Re: Remedial Action Work Plan Addendum
Site Remediation File No. SR-26-0934A/Formerly RIDEM Case No. 95-022
Former Tidewater Facility
200 Taft Street
Pawtucket, Rhode Island

RESPONSES TO RIDEM'S FEBRUARY 8, 2019 COMMENT LETTER

OVERALL REMEDIAL ACTION PLAN

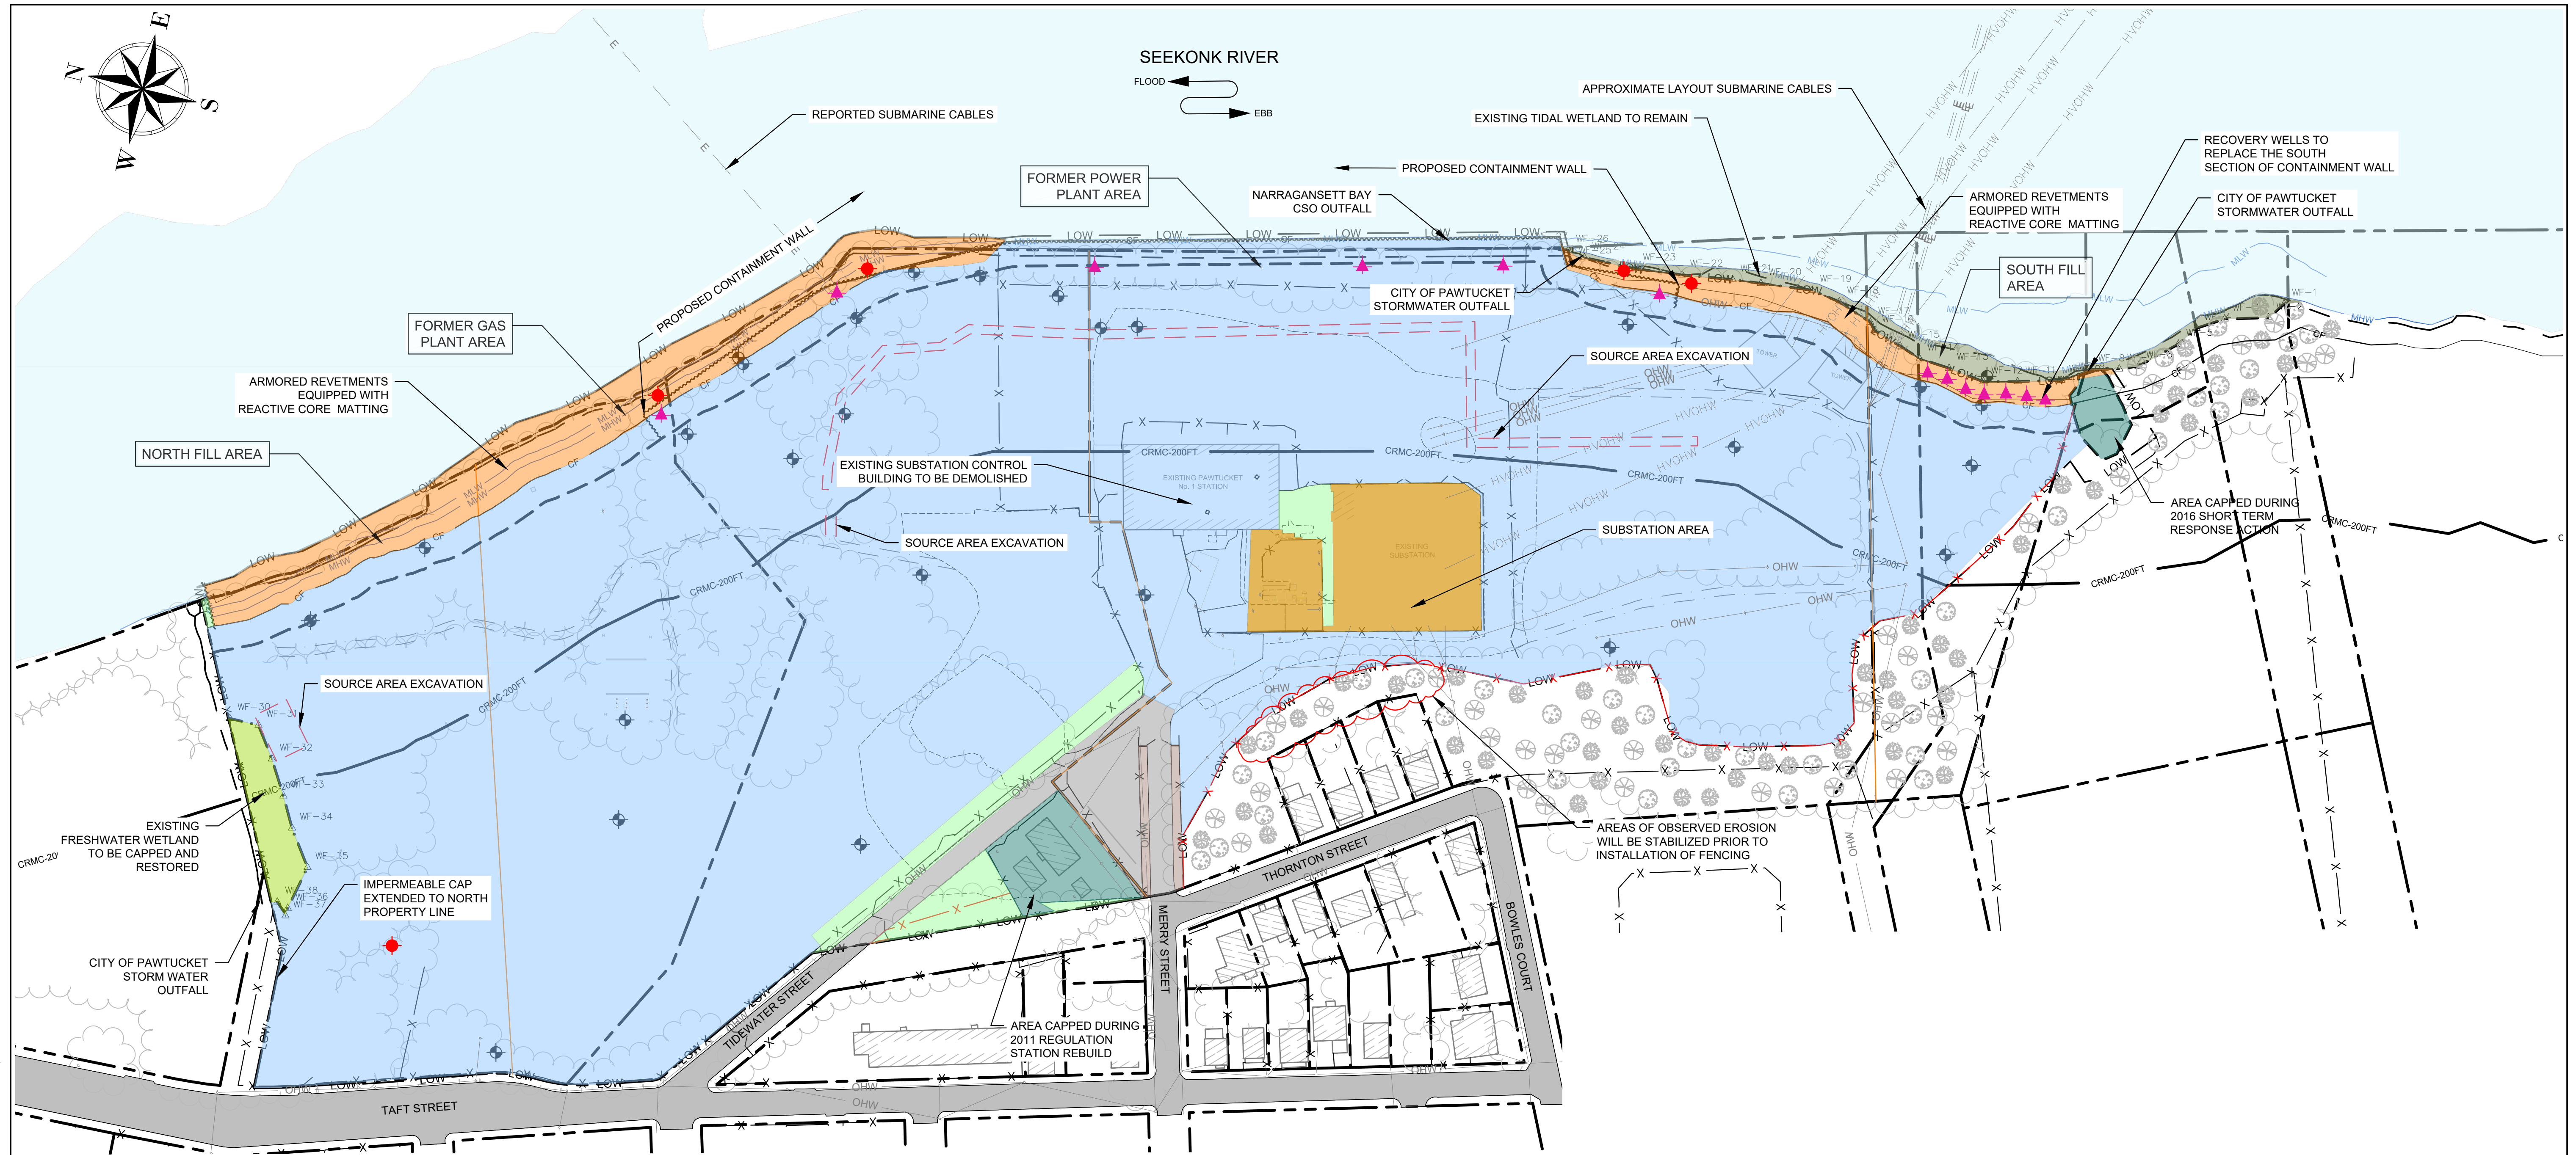
RIDEM Comment 4: As discussed with representatives of National Grid and GZA at the December 13, 2018 Site visit, please consider options for placement of monitoring wells downgradient of the containment wall. This remedial approach has been implemented at several other Sites in Rhode Island and provides a way to demonstrate that the containment wall is functioning as designed to prevent the off-site migration of contaminated groundwater.

Response: As shown on the attached updated Figure 18 from the RAWP, the central portion (approximately 580 feet) of the approximately 1,125-foot long containment wall will serve as a bulkhead between the land-based portion of the Site and the Seekonk River. In this portion of the containment wall, it is not feasible to install monitoring wells downgradient of the containment wall.

In the remaining sections of the containment wall, it will be feasible to install monitoring wells in a few isolated locations where land is available between the downgradient side of the containment wall and Mean High Water (MHW). As indicated on the attached updated Figure 18 from the RAWP, we anticipate the installation of 4 monitoring wells downgradient of the containment wall (2 wells downgradient of the northern portion of the containment wall and 2 wells downgradient of the southern portion of the containment wall). These wells will be equipped with screens extending from the top of the glacial till across the groundwater table to monitor for the presence of light and dense non-aqueous phase liquids (NAPLs).

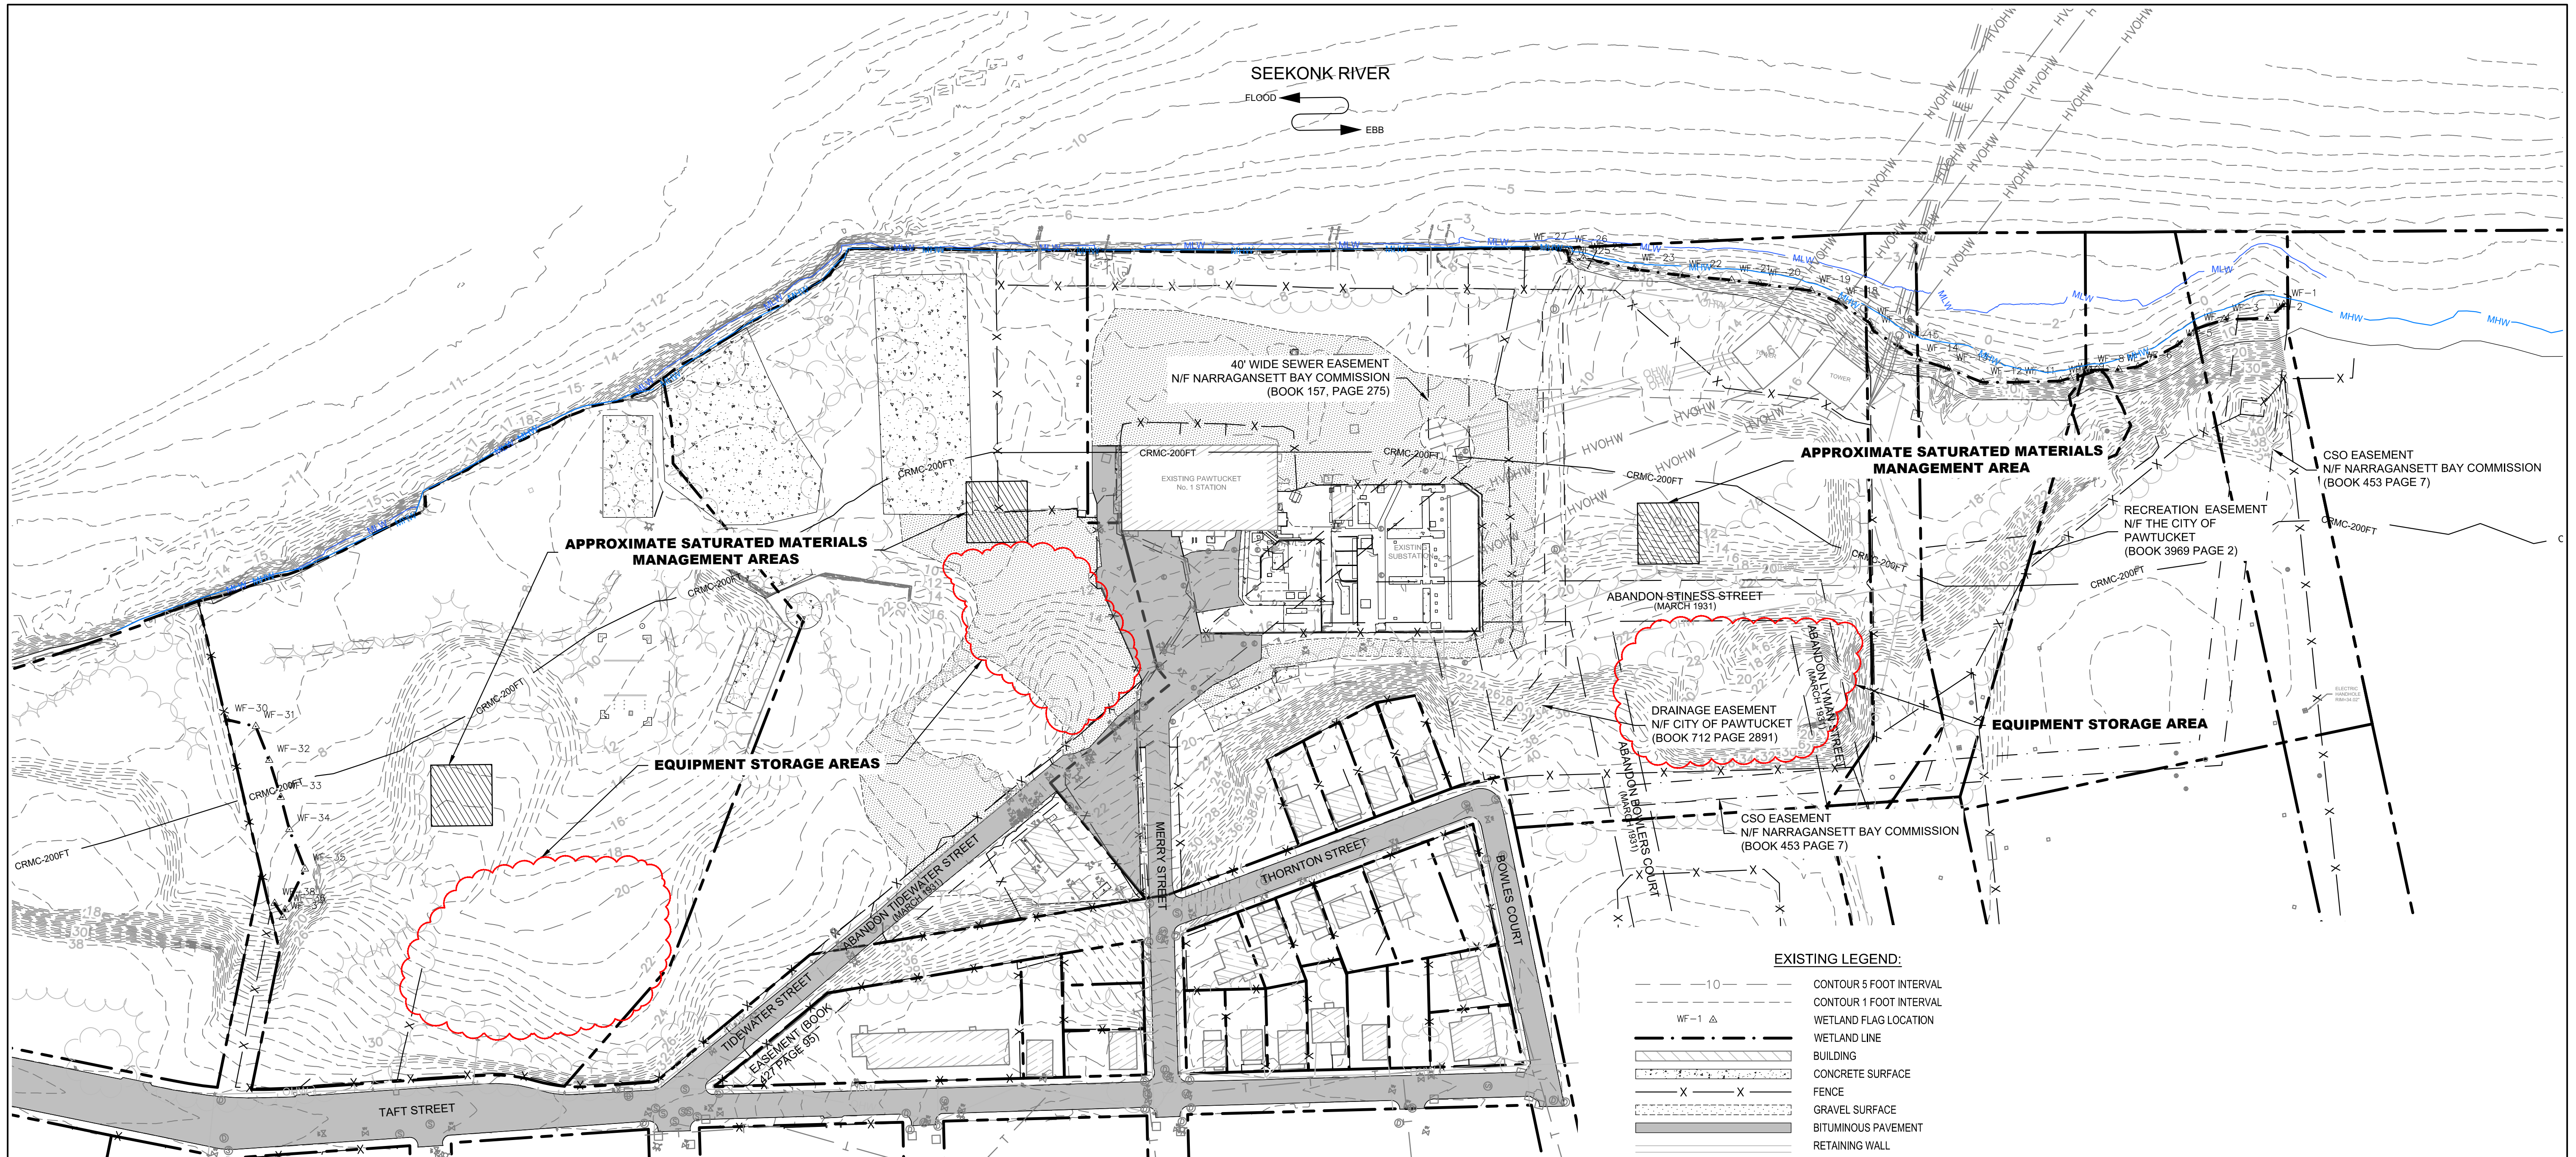
- c. Please provide a site figure identifying all proposed temporary stockpiling locations, temporary materials handling areas, and temporary equipment staging areas.

Response: The saturated materials management and equipment staging areas will be located outside the 200-foot CRMC limit in the approximate areas indicated on the attached Figure C-2. Note, the work will be performed in phases and the size and location of these staging areas may be modified as the work progresses

As indicated above, excavated soils that are not placed as fill on the same day will be temporarily stockpiled. It is not feasible to depict the location of these temporary stockpiles since the locations will likely be adjusted as the work progresses; however, these temporary stockpiles will be staged outside the 200-foot CRMC jurisdictional zone. As indicated above, stockpiles will be no larger than 1,000 CY and will be staged on top of and covered with a layer of polyethylene sheeting during the work days (to the extent practical) and during all non-working hours to control the generation of wind-blown dusts and potential migration of soils with stormwater runoff. Temporary erosion and sedimentation controls will also be installed surrounding the perimeter of the stockpiles.

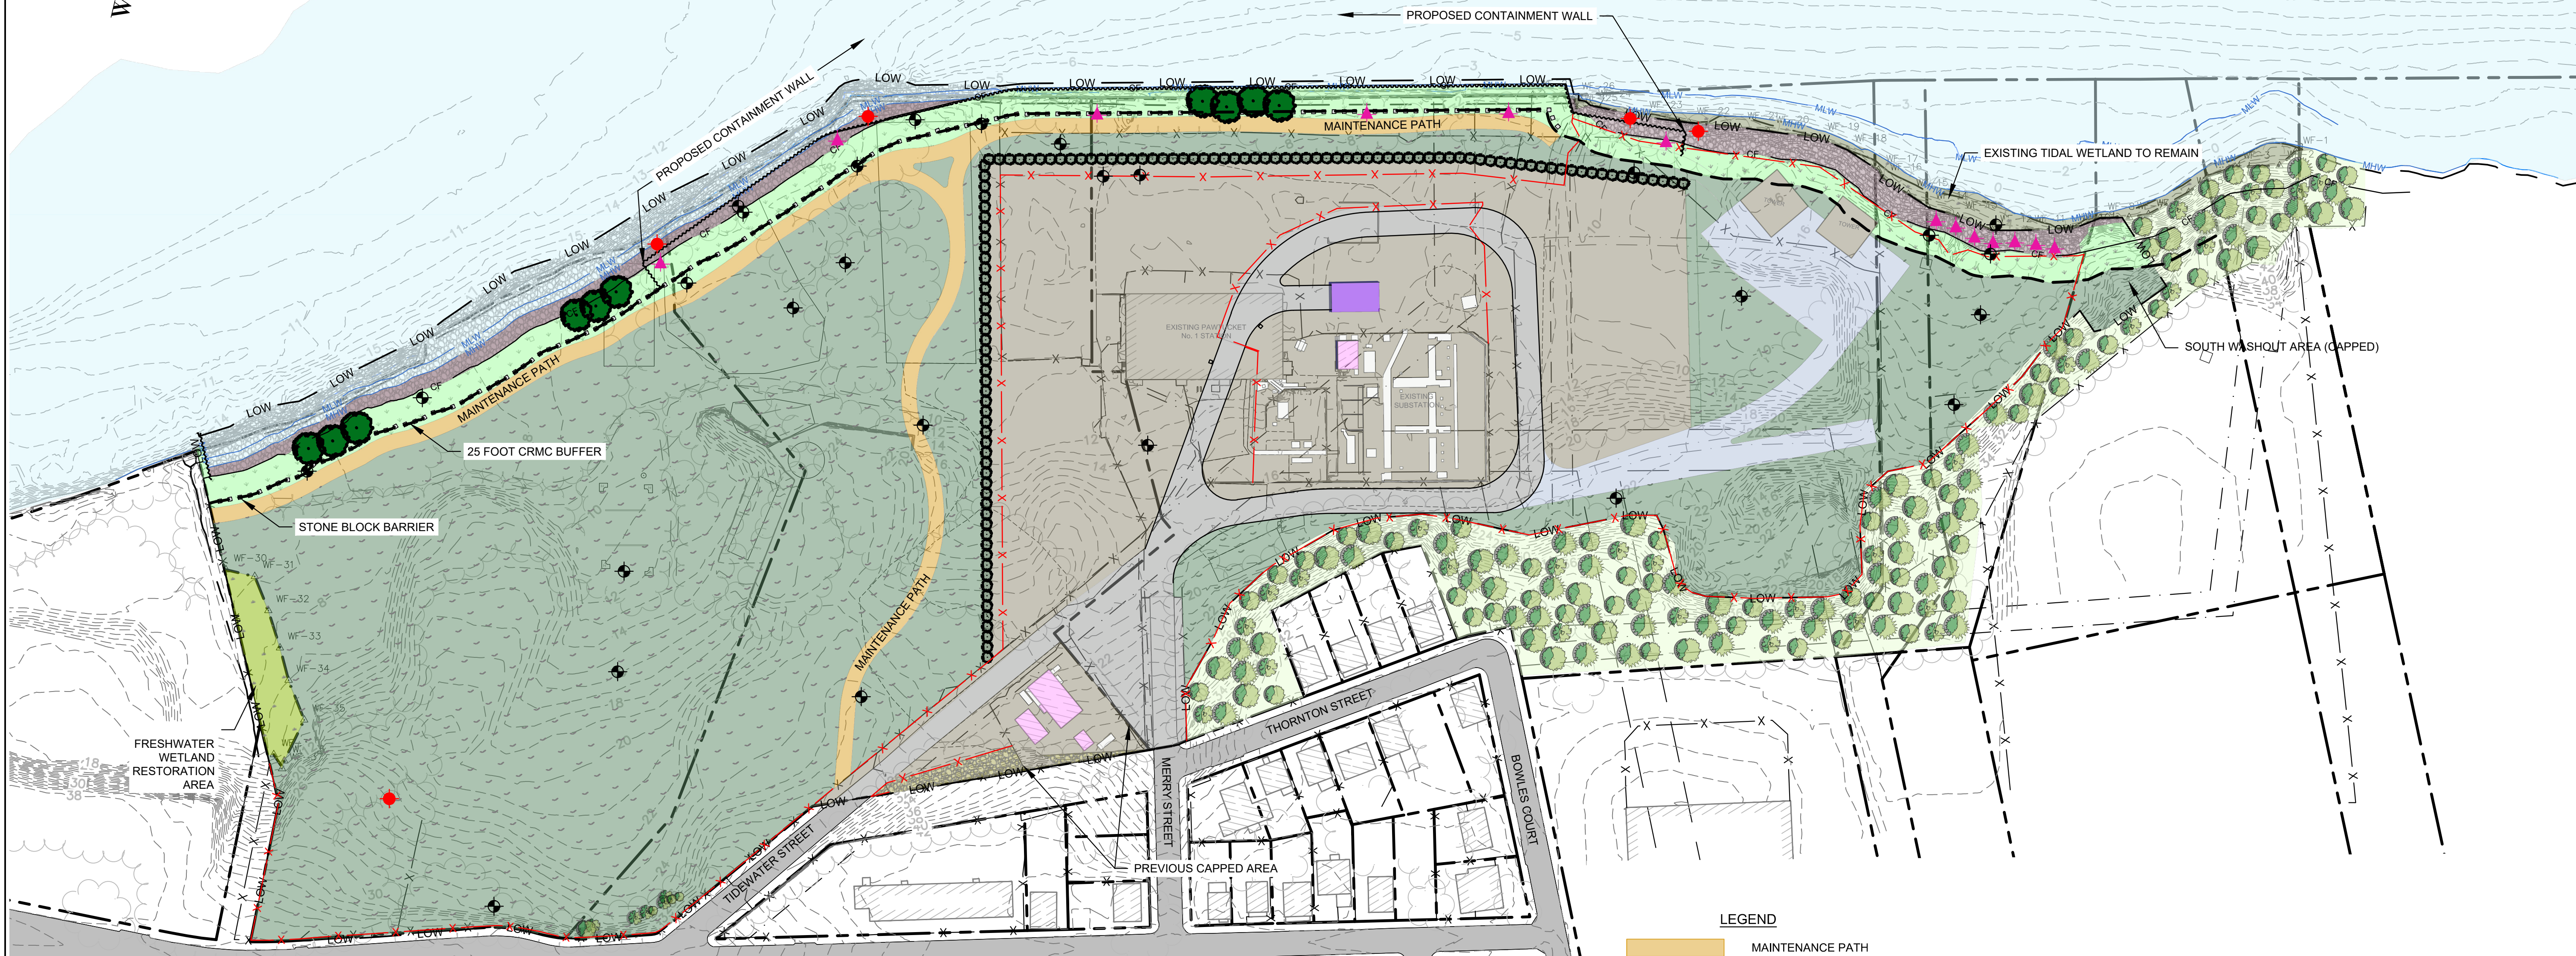
- **CRMC Comment #3:** Restoration of vegetated areas within 200' of the coastal feature is required post-remediation as follows. Current site conditions range from forested slope (southern extreme) to old field/sapling conditions (northern extreme) including development/asphalt/remnant structures. Proposed remediation includes an impermeable geotextile layer. Based on the above, reforestation is not a requirement for this site. However, a re-planting of disturbed areas with shallow-root native vegetation (shrubs and perennial grasses) is possible and will be required as part of Assent review. Any mature trees which can be retained on-site (specifically the southern area was noted to remain undisturbed) should be preserved. The width of the revegetation shall be based on current lot size. Parcels 80,000-200,000 sf on Type 4 waters required a 125' revegetated buffer zone. Parcels <200,000 sf require a 150' vegetated buffer zone. This revegetation shall only apply to those areas currently vegetated for purposes of this upcoming Assent review.

Response: As discussed during the April 2019 pre-application meeting, a 25-foot vegetated buffer will be installed along the entire riverfront. The vegetation within this buffer zone will consist of native species consistent with CRMC's Coastal Buffer Zone Planting Guide, Revised August 2008 with shallow root systems compatible with the engineered cap.

In the northern and southern portions of the Site, the upland area to the west of the 25-foot wide buffer will be re-vegetated with a meadow grass seed mix to minimize the maintenance of the engineered cap in these areas.

At the request of the City of Pawtucket, vegetation will also be planted to the north and east of the substation area to screen the substation from the river and the northern portion of the Site. This screening vegetation will also consist of native low maintenance species with a shallow root system compatible with the engineered cap.

A preliminary Overall Final Conditions Plan showing the extent of the buffer zone, the extent of the upland meadow, and the substation screening is attached for reference. The combined permit application package submitted to the regulatory agencies will include an updated version of this plan that identifies the type and density of plant species within the buffer zone and for the substation screen.
